Figure 1. Relation Of Water-Level Decline To Pumping Estimates For Chowchilla Water District. *The solid line represents the original relation developed by Dr. Schmidt. The dashed lines represent the water-level-pumping equation with incorporation of error described in Burt and others (2002).*

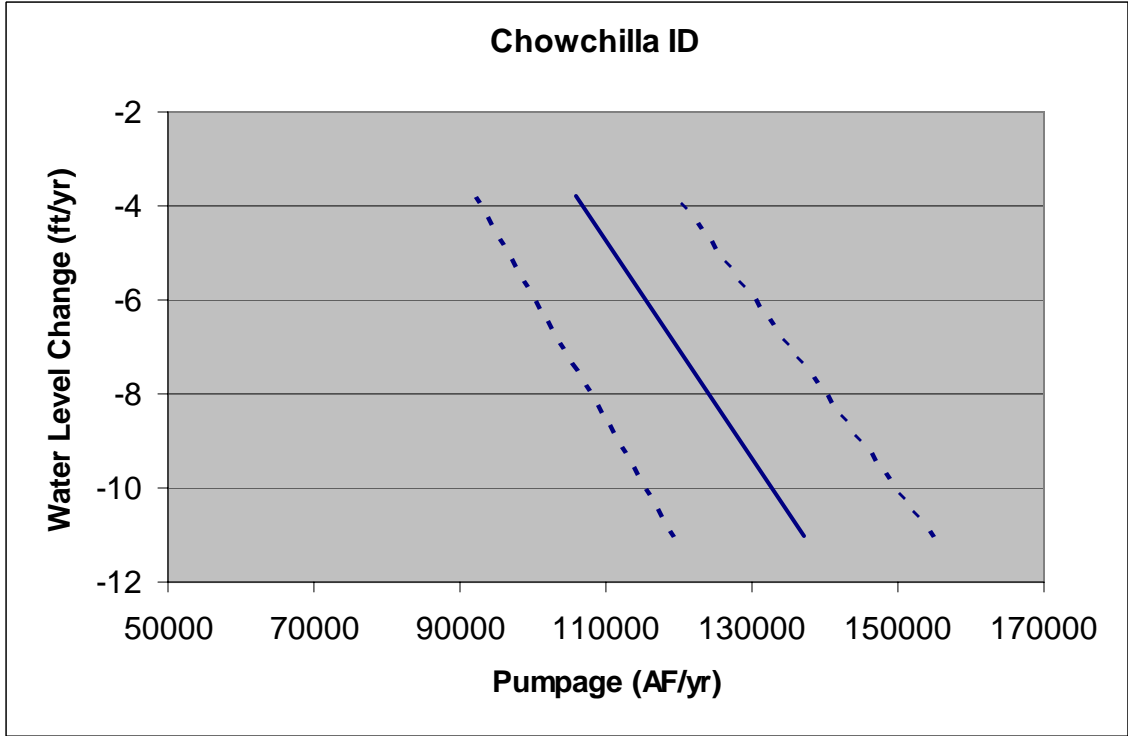
21. Alternatively, the uncertainty in estimated groundwater pumping can be examined by incorporating the $\pm 13\%$ uncertainty in the redevelopment of Dr. Schmidt's equations. In other words, we can determine how the straight-line equations would change if actual pumpage was different than estimated by Dr. Burt. Figure 1 illustrates the possible range in actual pumping causing the observed groundwater level decline in Chowchilla ID. To create Figure 1, the average annual groundwater pumping during 1987-1999 was adjusted by 13% and used to create uncertainty boundaries for the straight-line relationships developed by Dr. Schmidt. For example, the range in actual pumping causing the observed 4 feet per year groundwater decline is 90,500 AFA to 118,000 AFA.

Figure 2. Groundwater Contours And Generalized Directions Of Groundwater Flow For 1999. (Adapted from Department of Water Resources groundwater level map for the unconfined zone).

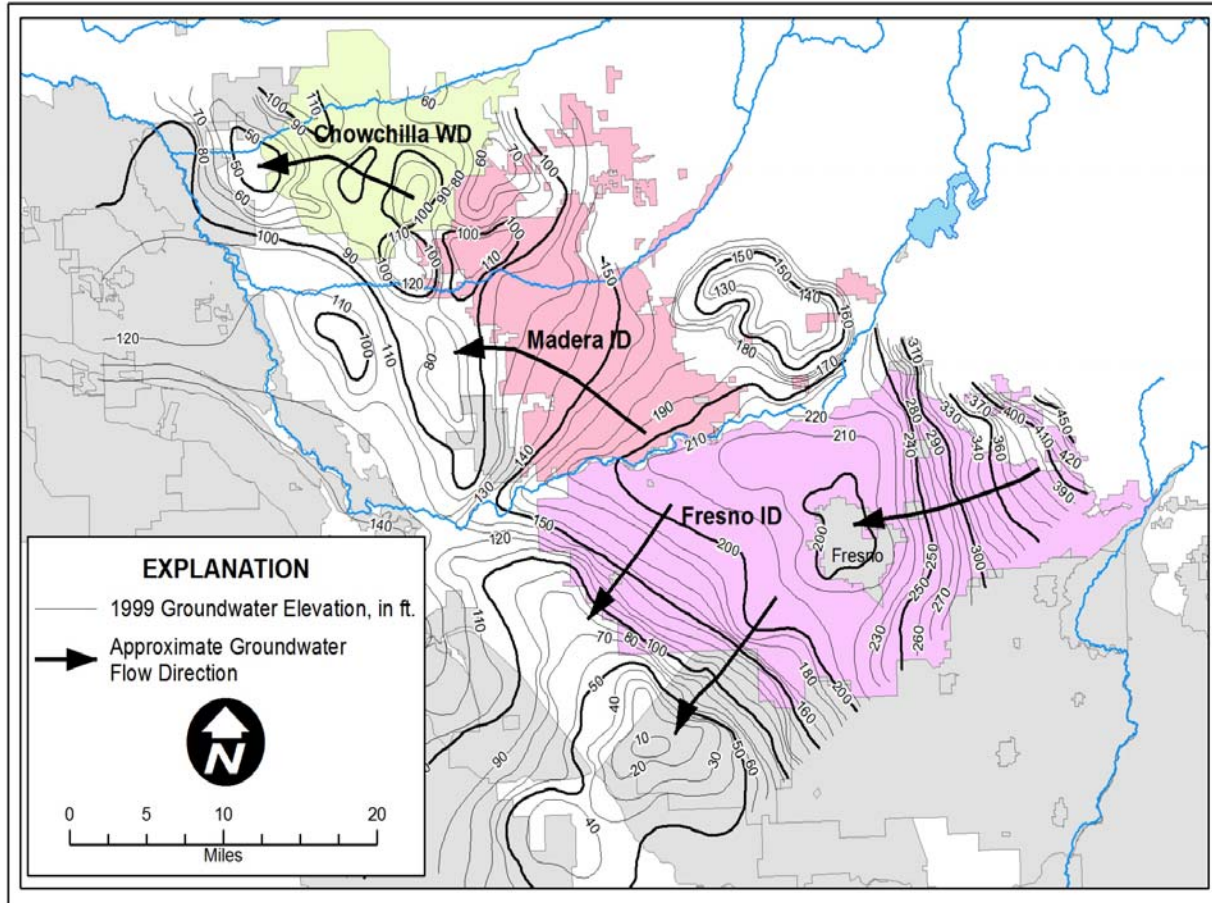
6 33. Figure 2 shows groundwater level contours developed by the Department of
7 Water Resources for 1999, a normal dry year. The contours show lines of equal groundwater
8 levels, from which the horizontal movement of groundwater beneath the subsurface is inferred;
9 groundwater moves from locations of relatively high levels to lower levels. The groundwater
10 level contour map shows that groundwater moves away from 3 Friant districts: Fresno,
11 Madera and Chowchilla. Throughout most of the Chowchilla Water District, groundwater
12 flow is generally east to west, and the groundwater level contours indicate water moves toward
13 a pumping depression located west of the district. Throughout most of the Madera Irrigation
14 District, groundwater flow is in a northwesterly direction toward a pumping depression located
15 west of the district. In the eastern part of the Fresno Irrigation District, groundwater flows

16 toward a pumping depression beneath the city of Fresno, and in the western part of the Fresno
17 Irrigation District groundwater flows toward a pumping depression located southwest of the
18 district. In another example, Fugro (2003) reported lateral groundwater flow leaving the
19 Kaweah Delta Water Conservation District which contains the Tulare Irrigation District, one of
20 the larger Friant districts.

Figure 3. Relation Of Measured Gains In Reach 4 To Deliveries.¹² Labels next to data points in show the year and water year type (W = wet, NW = normal wet, ND = normal dry D = dry).

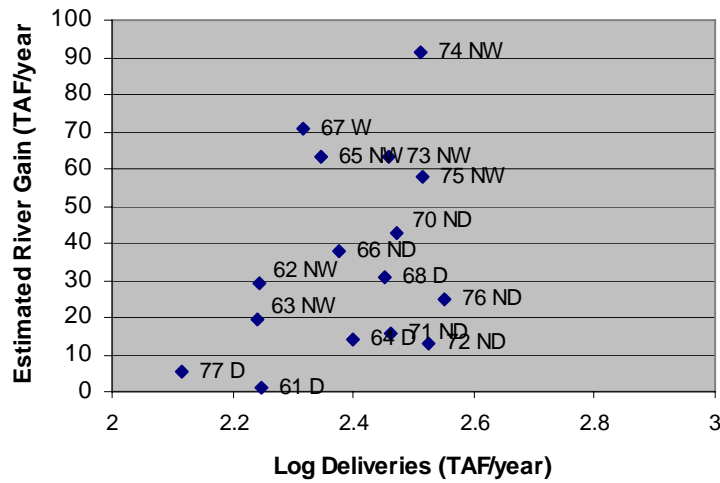
19 78. In my August 15, 2005 report, I described and showed the relation of Delta
20 Mendota Canal deliveries to river gains in Figure 1.22. I have subsequently determined that
21 some of the data used in the graph was in error. I now attach Figure 3 and provide the
22 following as my correct opinion on this issue. My conclusion expressed on the relation of
23 estimated River gains in Reach 4 relative to deliveries has not changed. I elaborate here.

79. I related the magnitude of gain in River Reach 4 related to deliveries via the Delta Mendota Canal (DMC) and San Luis Canal from 1961 to 1977. Figure 3 shows the relation of annual river gains estimated by Mullen and Nady (1985) to annual deliveries to

Figure 4. Annual Deliveries From 1961 to 1977.

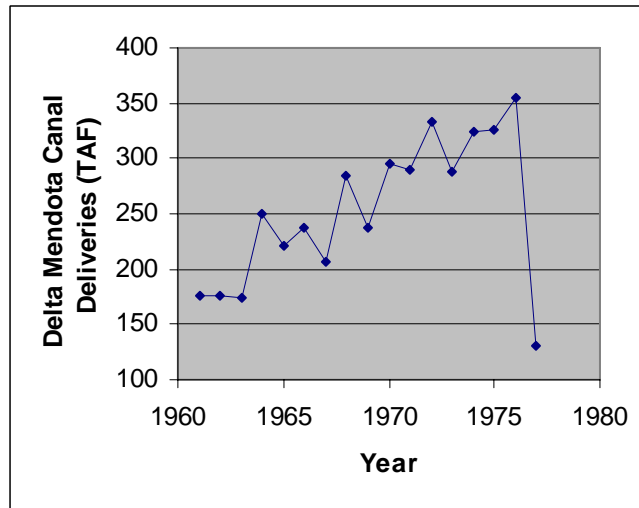
1 selected water districts via the Delta Mendota and San Luis Canals.¹³ These canals were
2 increasing deliveries during this time period in areas upgradient of River Reach 4 (Figure 4)
3 and probably contributed to increased groundwater levels. Figure 3 indicates that increasing
4 water deliveries may have contributed to increasing River gains in Reach 4. Specifically, gains
5 tend to increase with increasing deliveries. Figure 3 also shows that water year type also
6 substantially influences the relation. Dry and normal dry year types generally show indicate
7 less gain relative to deliveries. Wet and normal wet year types generally show more gain
8 relative to deliveries. In general, deliveries to the western San Joaquin Valley resulted in
9 increasing groundwater levels in the western San Joaquin Valley since the 1950's (Belitz and
10 Heimes, 1990).
